PUBLIC INTEREST REVIEW FOR GROUND WATER APPLICATIONS

SUBJECT: Application G-18276 Supersedes review of _____
Date of Review(s)

Applicant's Name: Justin R. & Jayna L. Ferrell County: Lake

A1. Applicant(s) seek(s) 0.88 (395 gpm) cfs from 1 well(s) in the Goose and Summer Lakes Basin,
Lake Abert (Chewaucan) sub basin Quad Map: Valley Falls

LAKE 52618 to Crooked Creek

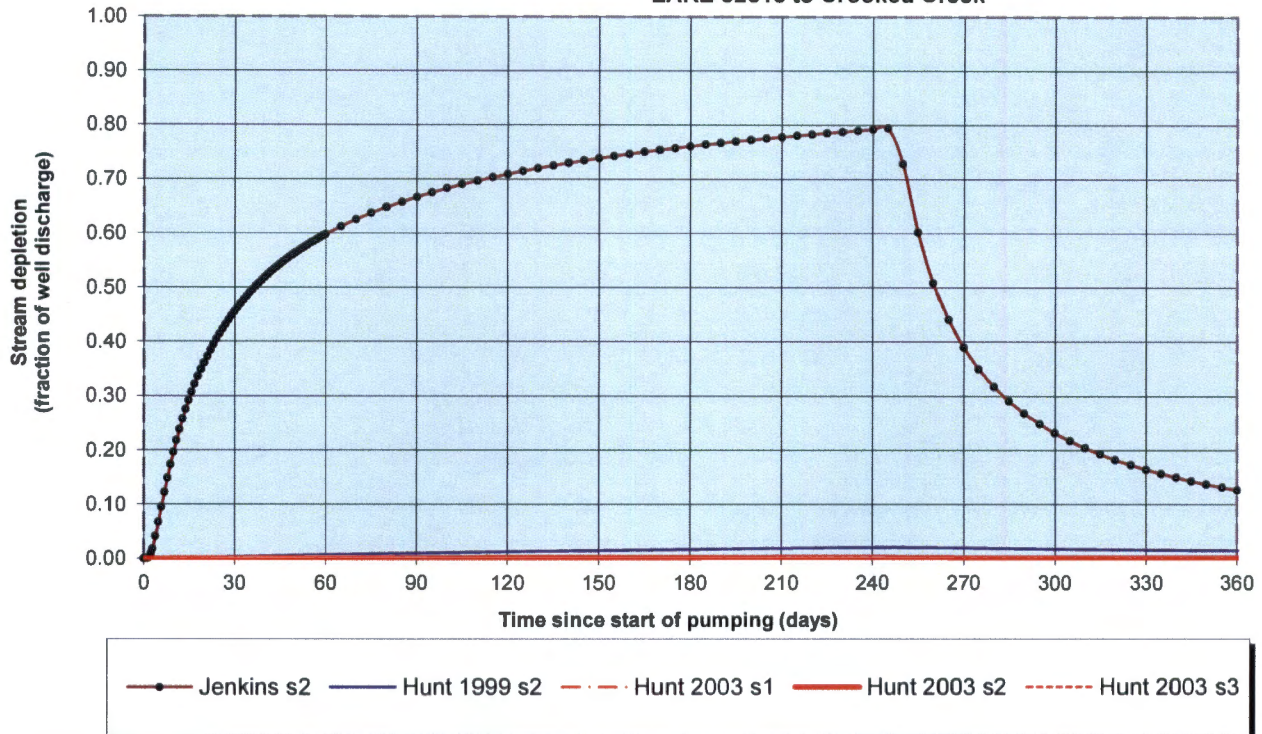
SW# 1 is Crooked Creek. The proposed POA well is more than 1.0 mile from Crooked Creek.

Hunt (2003) was used to calculate the interference given the proposed POA well obtains groundwater from the predominantly basalt-volcanic rock and sediment unit below the predominantly basin fill sediment unit, and obtaining groundwater solely from that unit is a recommended permit condition. The calculations used a horizontal hydraulic conductivity of 30 feet/day (transmissivity = 15,000 ft²/day which is consistent with Morgan (1988) and McFarland and Ryals (1991)), a vertical conductivity of 0.3 feet/day, 0.01 for the storage coefficient, and a basin-fill sediment thickness of 350 feet at the stream (based on LAKE 52274). The stream width used for the calculation (100 feet) is approximate to wide stream width sections. A smaller stream width would result in a smaller calculated interference. A pro-rated pumping rate of 0.44 cfs (total maximum annual volume allowed divided by 245 day irrigation season) was used for the calculation.

When obtaining groundwater from the predominantly basalt-volcanic rock and sediment unit, the calculated interference with the creek for each month remains less than 1.00 percent of the natural stream flow (80 percent exceedance). It should be noted that pumping groundwater from the predominantly basin-fill unit would likely result in interference with the creek that exceeds the 1.00 percent of the natural stream flow (80 percent exceedance) during some months.

LAKE 52618 to Chewaucan River

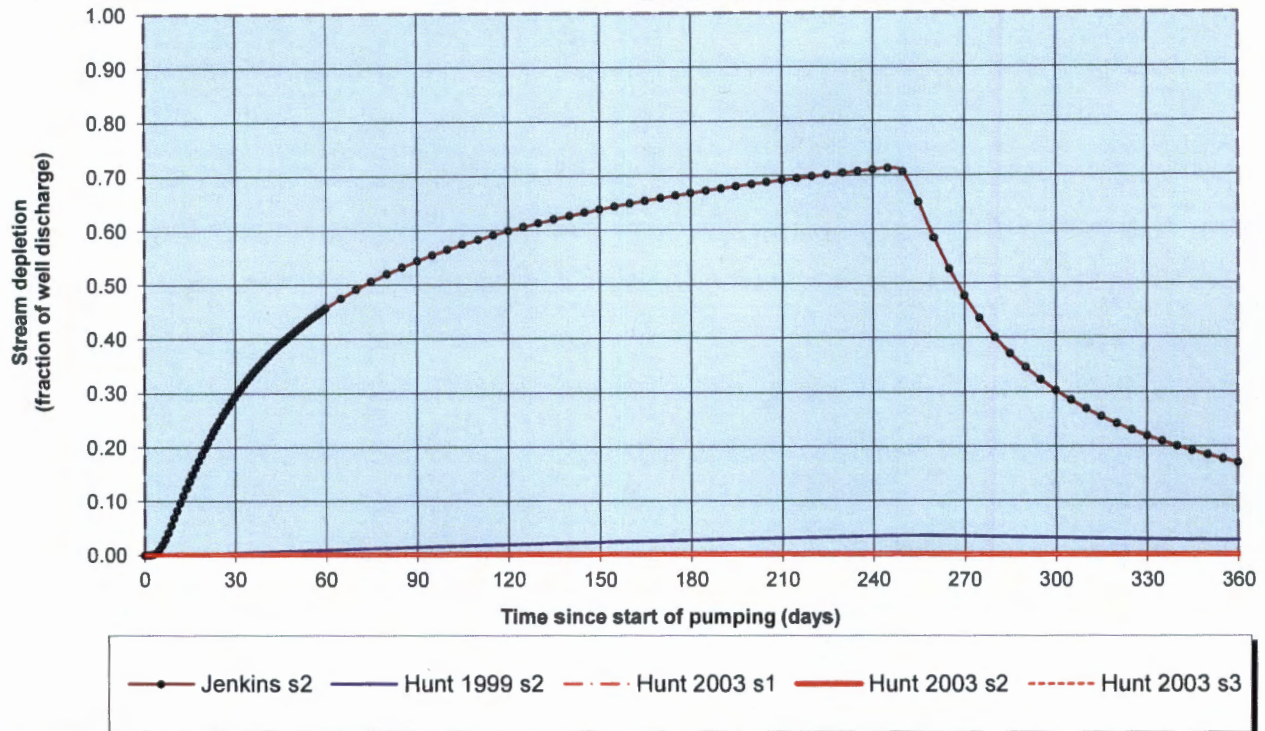
SW# 2 is the Chewaucan River. The proposed POA well is more than 1.0 mile from the Chewaucan River.

Hunt (2003) was used to calculate the interference given the proposed POA well obtains groundwater from the predominantly basalt-volcanic rock and sediment unit below the predominantly basin fill sediment unit, and obtaining groundwater solely from that unit is a recommended permit condition. The calculations used a horizontal hydraulic conductivity of 30 feet/day (transmissivity = 15,000 ft²/day which is consistent with Morgan (1988) and McFarland and Ryals (1991)), a vertical conductivity of 0.3 feet/day, 0.01 for the storage coefficient, and a basin-fill sediment thickness of 350 feet at the stream (based on LAKE 52274). The stream width used for the calculation (100 feet) is approximate to the actual stream width. A smaller stream width would result in a smaller calculated interference. A pro-rated pumping rate of 0.44 cfs (total maximum annual volume allowed divided by 245 day irrigation season) was used for the calculation.

When obtaining groundwater from the predominantly basalt-volcanic rock and sediment unit, the calculated interference with the river for each month remains less than 1.00 percent of the natural stream flow (80 percent exceedance).
